OIL - AIR COOLED OIL COOLER AIR MODULATING VALVE - ACTUATOR ASSEMBLY- INTRODUCTION OF
IMPROVED SEALING - CATEGORY CODE 7 - MOD.ENG-79-0043

V2500-ENG-79-0043

SERVICE BULLETIN

Location of Air Modulating Valve (A1 and A5 Engines)
Fig.1

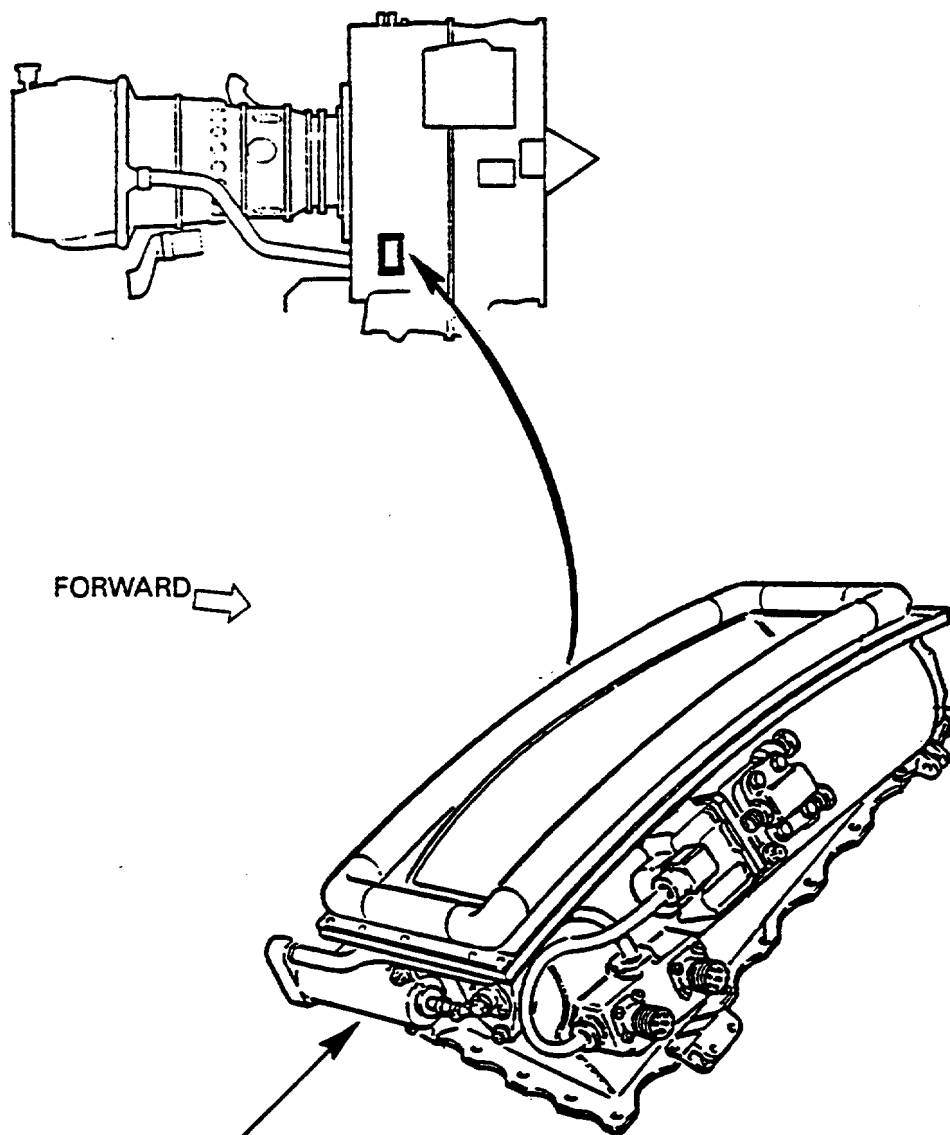
REMOVE TY1558-51 AND
INSTALL TY1558-51 OR TY1558-52
